Responses to Comments on the Draft EA

On November 18, 2019, the FAA released the Draft Environmental Assessment (EA) for the proposed Las Vegas Metroplex Project for public review and comment. The comment period ran for 64 days and closed on January 21, 2020. The FAA recognizes the importance and value of public input in this process.

Figure 1: GIDGT/RATPK Extended to Blue Diamond Road

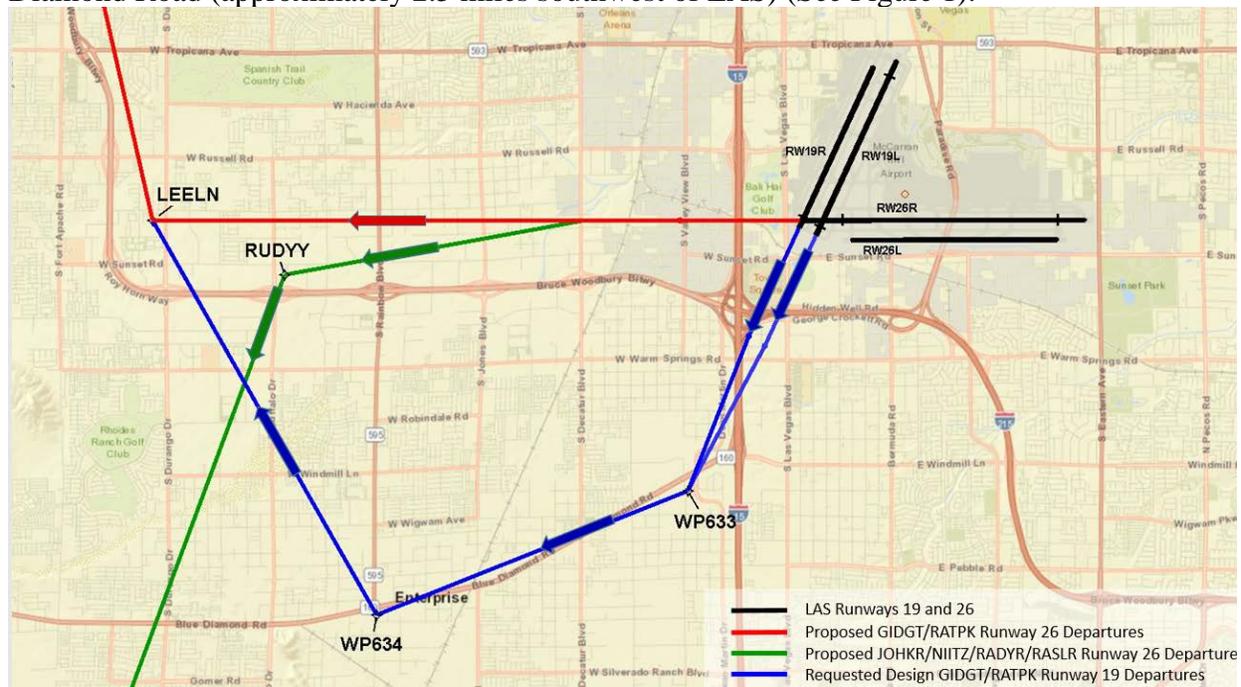
The FAA evaluated a design that delayed making a right turn to LEELN until crossing Blue Diamond Road (approximately 2.5 miles southwest of LAS) (See Figure 1).

The FAA determined that in addition to the criteria failures, the suggested route over Blue Diamond Road would reduce efficiency due to increased delays for departures from separate runways and increase miles flown. Also, extension of the RATPK and GIDGT departure procedures could present a situation where LAS Runway 19 departures would be routed nearly head on toward aircraft on LAS JOHKR, NIITZ, RASLR and RAYDR departure procedures departing LAS Runway 26 (See Figure 1).

Figure 1: GIDGT/RATPK Extended to Blue Diamond Road

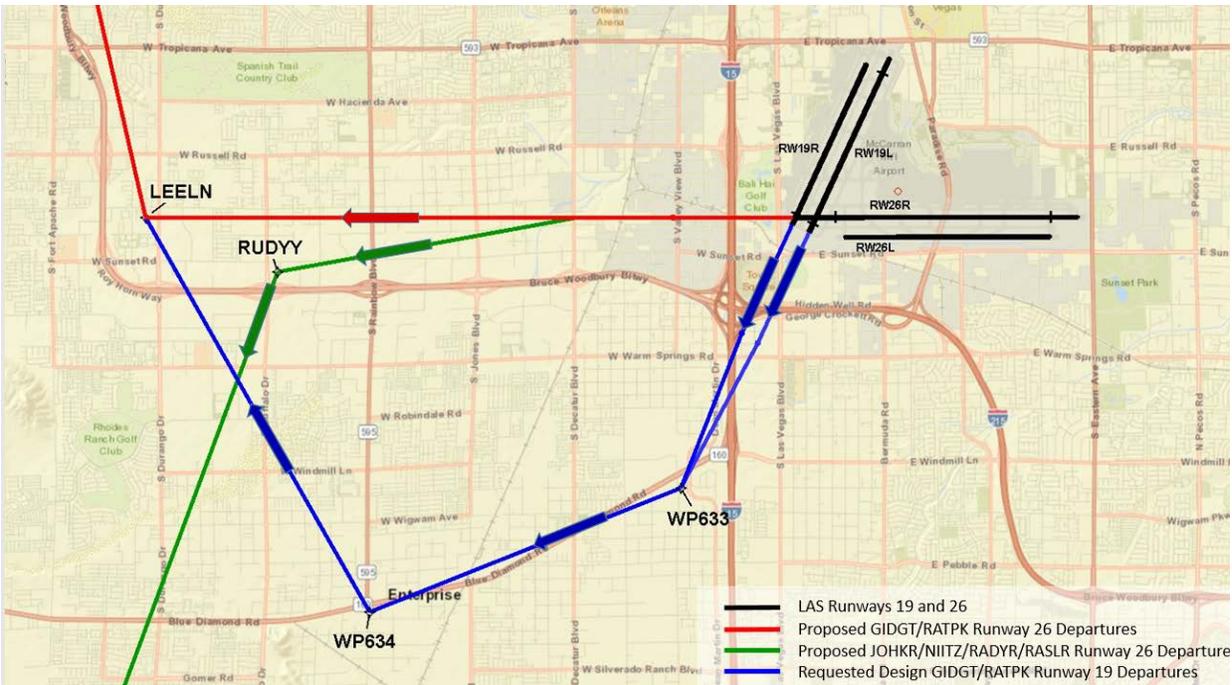
The FAA evaluated a design that delayed making a right turn to LEELN until crossing Blue Diamond Road (approximately 2.5 miles southwest of LAS) (See Figure 1).

The FAA determined that in addition to the criteria failures, the suggested route over Blue Diamond Road would reduce efficiency due to increased delays for departures from separate runways and increase miles flown. Also, extension of the RATPK and GIDGT departure procedures could present a situation where LAS Runway 19 departures would be routed nearly head on toward aircraft on LAS JOHKR, NIITZ, RASLR and RAYDR departure procedures departing LAS Runway 26 (See Figure 1).
